Project	IEEE 802.16 Broadband Wireless Access Working Group < http://ieee802.org/16 >	
Title	Restructuring and Renaming of Management Primitives in section 14.2.9	
Date Submitted	2006-0405-3002	
Source(s)	Jaesun Cha	jscha@etri.re.kr
	ETRI	
	Ronal Mao	rmao@huawei.com
	Huawei Technologies Co., Ltd.	
	Ronny (Yong-Ho) Kim	ronnykim@lge.com
	LG Electronics, Inc.	
Re:	Contribution on comments to IEEE 802.16g/D2	
Abstract	In this contribution, we propose to define some primitives for Neighbor BS Management.	
Purpose	Adoption	
Notice	This document has been prepared to assist IEEE 802.16. It is offered as a basis for discussion and is not binding on the contributing individual(s) or organization(s). The material in this document is subject to change in form and content after further study. The contributor(s) reserve(s) the right to add, amend or withdraw material contained herein.	
Release	The contributor grants a free, irrevocable license to the IEEE to incorporate text contained in this contribution, and any modifications thereof, in the creation of an IEEE Standards publication; to copyright in the IEEE's name any IEEE Standards publication even though it may include portions of this cont

Figure 505—The use of primitives to generate MAC management messages

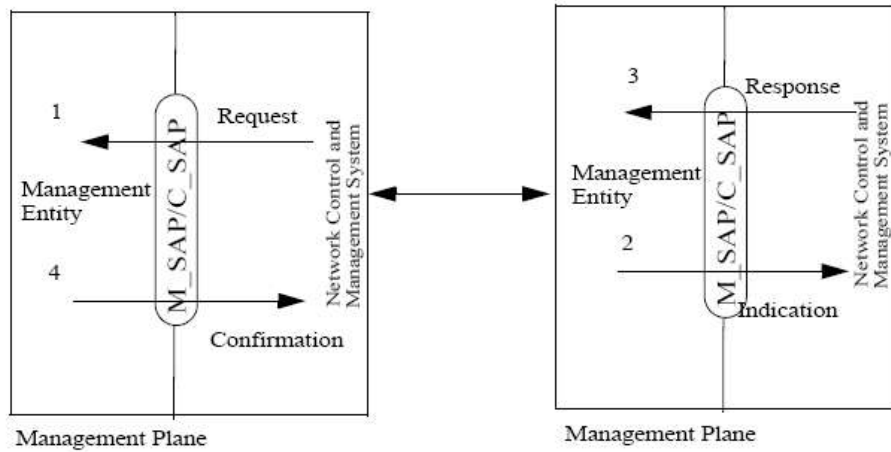
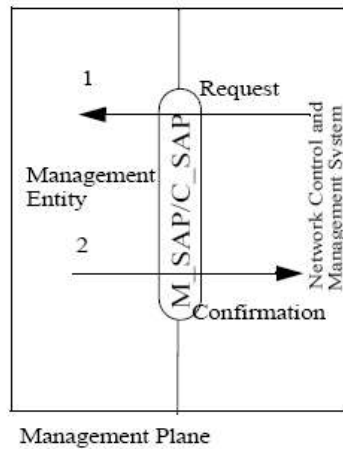
~~The use of these primitives to provide peer communication is shown in Figure 3. The use of primitive can be divided into two categories. The first category is with interaction with the peer entity, and the second category is primitive exchange within local stack.~~

~~The initial request for service from a higher layer through NCMS is provided by the "Request" primitive. The request triggers to generate appropriate MAC management message and the MAC management message is sent across the air interface to the peer MAC.~~

~~Upon reception of the MAC management message over the air interface, corresponding "Indication" primitive is generated to inform NCMS of the request; When the response for the request is made from the higher layer, the response is delivered through the NCMS by the "Response" primitive. The response triggers to generate appropriate response MAC management message and this message is transmitted over the air interface to the originating side. Upon reception of the response MAC management message over the air interface, corresponding "Confirmation" primitive is generated and delivered to higher layer via NCMS.~~

~~Primitives exchange for the unidirectional MAC management messages, which don't require response messages, such as MOB_HOIND, MOB_TRF-IND, and for the local management of the MAC state machine, is shown in Fig. 3, (2). The initial request for service from a higher layer through NCMS is provided by the "Request" primitive. The request triggers either to generate appropriate unidirectional MAC management message or MAC state change depending on the primitive. "Confirmation" primitive conveying the result of the request is delivered to the higher layer through NCMS.~~

[Modify section 14.2.9 as follow]

14.2.9 Network Entry Management Primitives

The Network Entry Management Primitives are a set of primitives for supporting network entry and network re-entry procedures between 802.16 Entity and NCMS.

Figure 506 — The use of Ranging Primitives Figure 506a Ranging Primitives (MS Side)

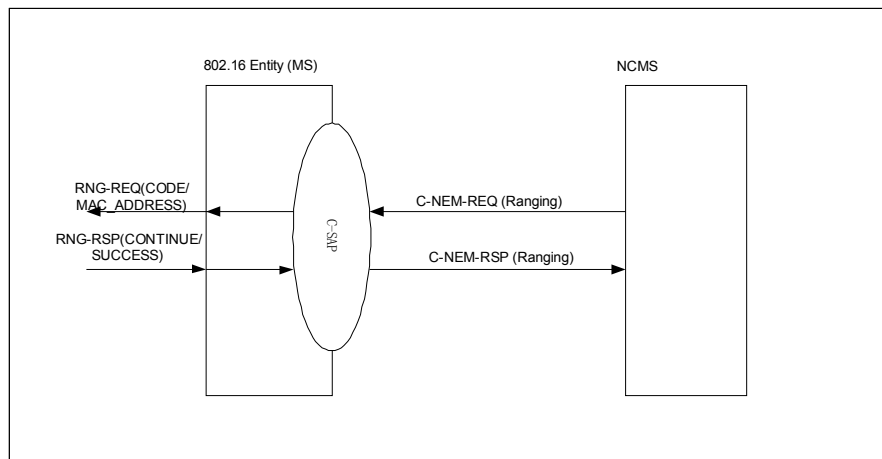
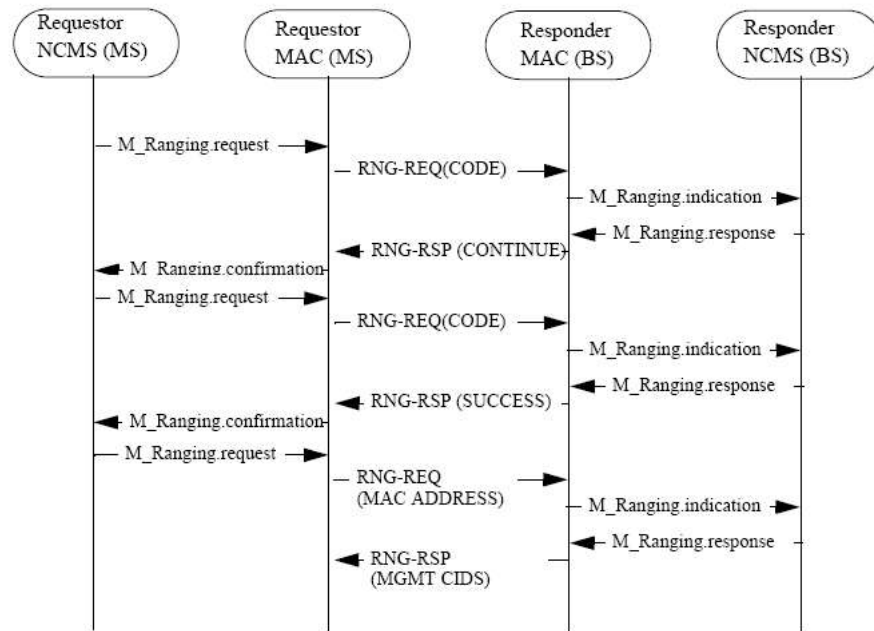
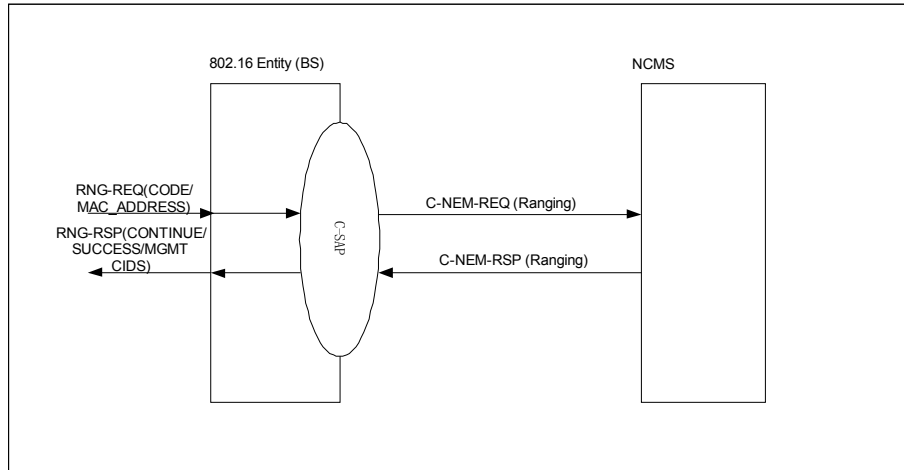
[Modify section 14.2.9.1 as follow]

14.2.9.1 M_Ranging-request/indication/response/confirmationRanging Primitives

Upper layers can control ranging procedure with these primitives. Upper layers shall commence 802.16 link setup procedure by sending M_NEM-REQ(Ranging)M_Ranging-request primitive through NCMS.

Figure 507 – The use of Registration Primitives [Figure 507a Registration Primitives \(MS Side\)](#)

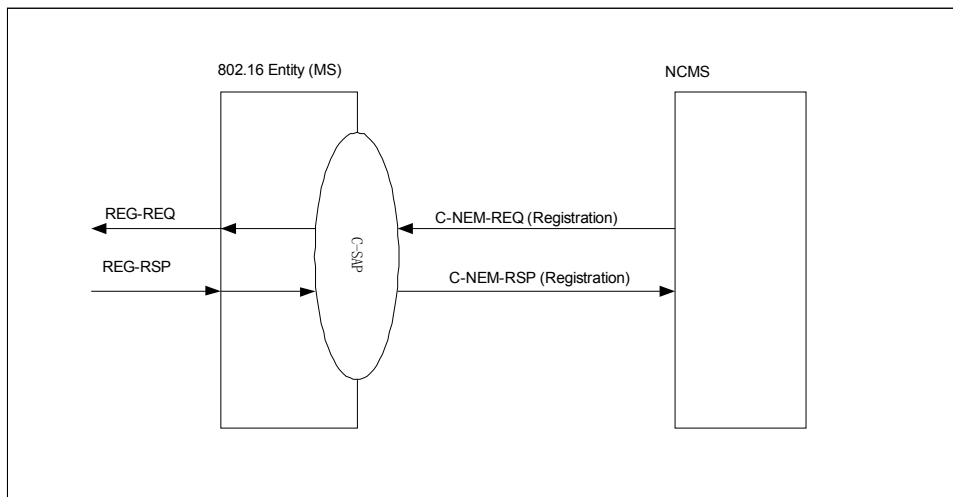
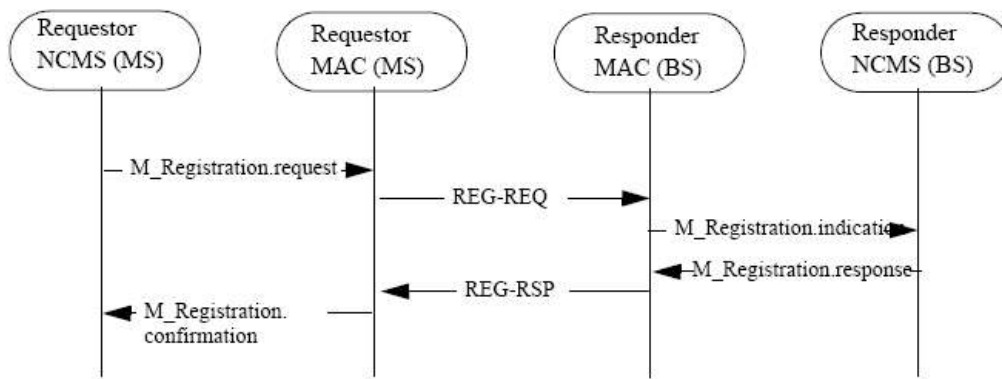
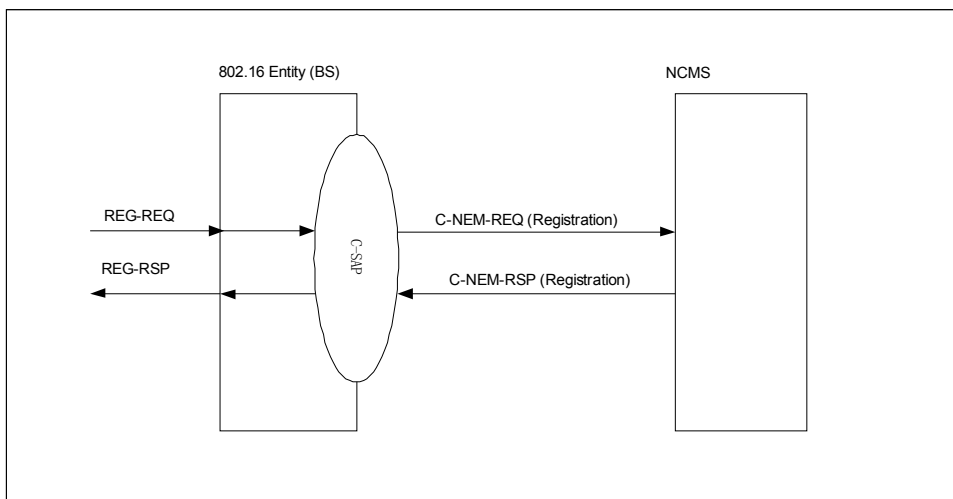
[Modify section 14.2.9.2 as follow]

14.2.9.2 M_Registration.request/indication/response/confirmationRegistration Primitives

Upper layers can control registration procedure with these primitives. Upper layers are notified of link setup by M_Registration_confirmation: C-NEM-RSP/Registration.

Figure 508 – The use of Neighbor Advertisement Indication Neighbor Advertisement Primitives

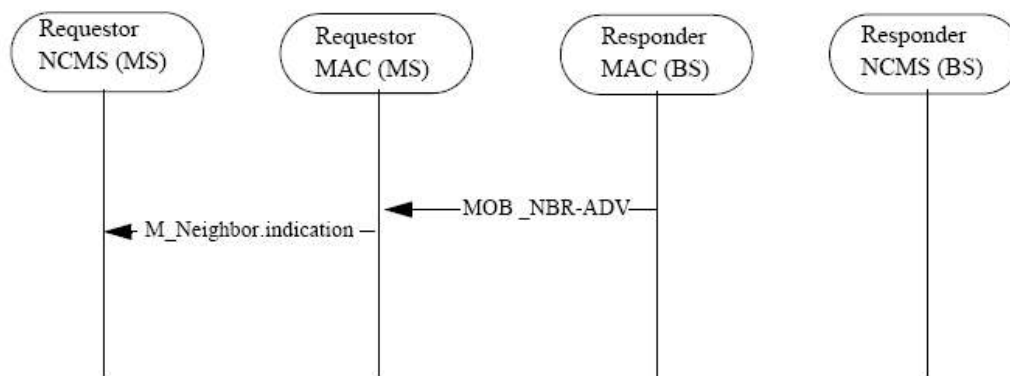
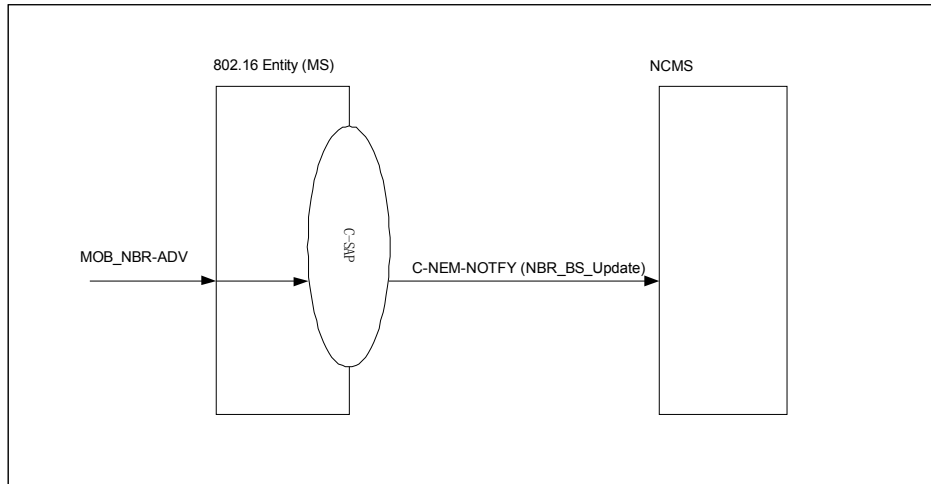
[Modify section 14.2.9.3 as follow]

14.2.9.3 Neighbor Advertisement Primitives ~~M-Neighbor.indication~~

When 802.16 MAC receives neighbor advertisement (MOB_NBR-ADV), this primitive is used to deliver the information to upper layers.

Figure xxx – Mobile Terminal Management primitives flow between 802.16 Entity and NCMS, De-Registration

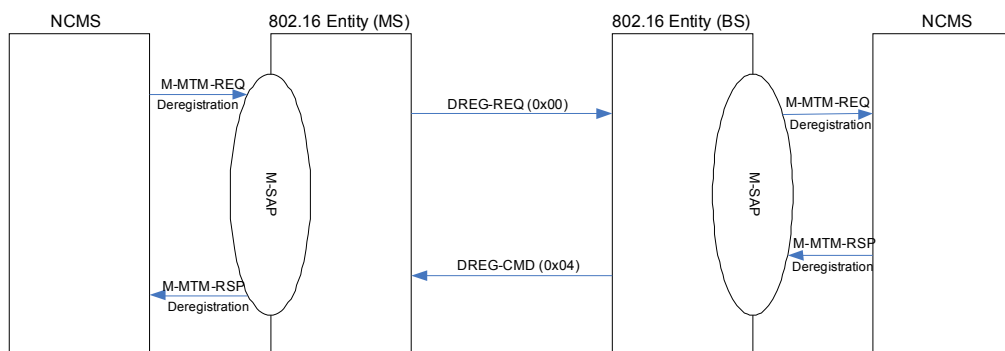
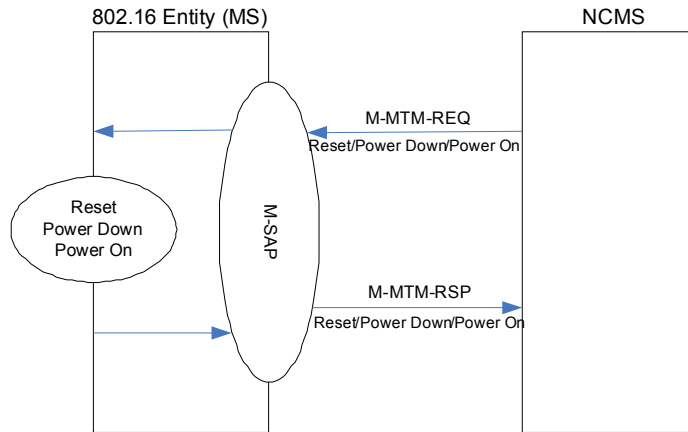
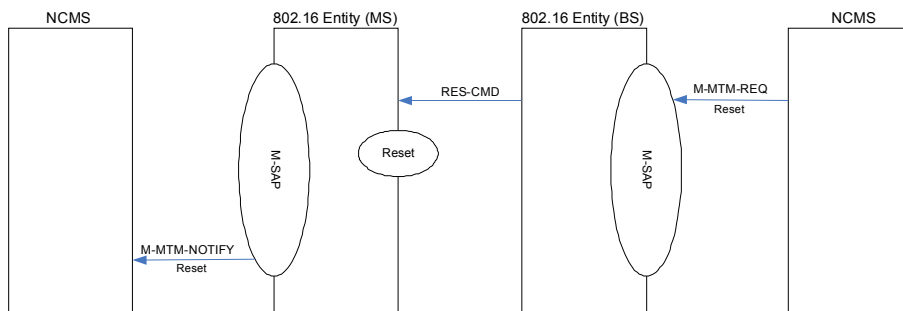
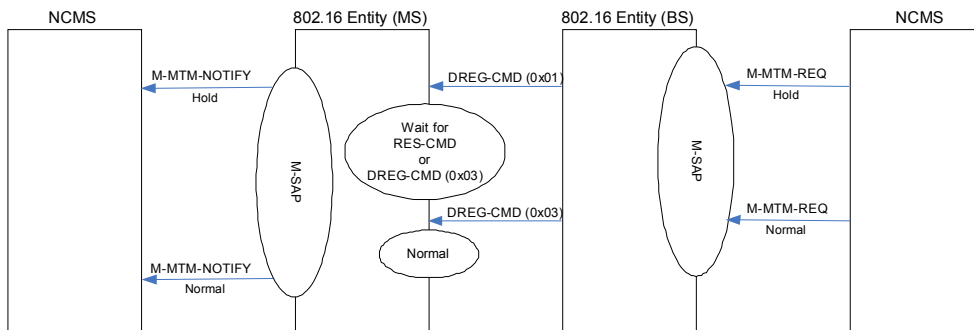
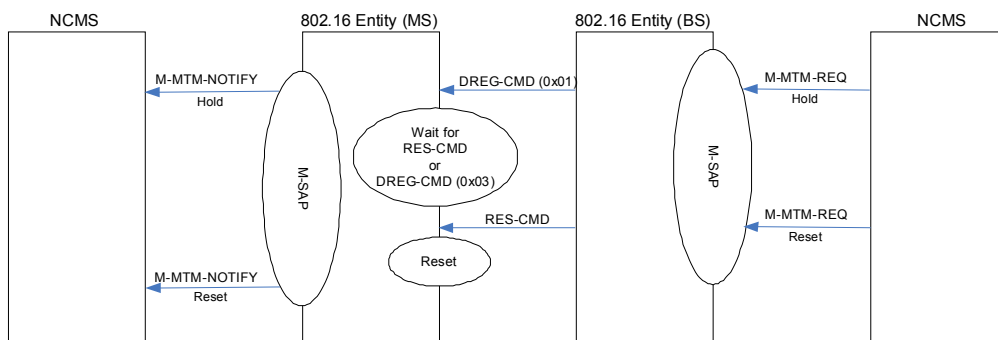
[Create a New Section 14.2.10 as follow]

14.2.10 Mobile Terminal Management

The Mobile Terminal Management Primitives are a set of primitives to manage the status of mobile terminal. A management entity in NCMS can change the status of mobile terminal into power on/down/de-register, etc. Those primitives are also used to notify NCMS of information or events which are related with the status of mobile terminal.
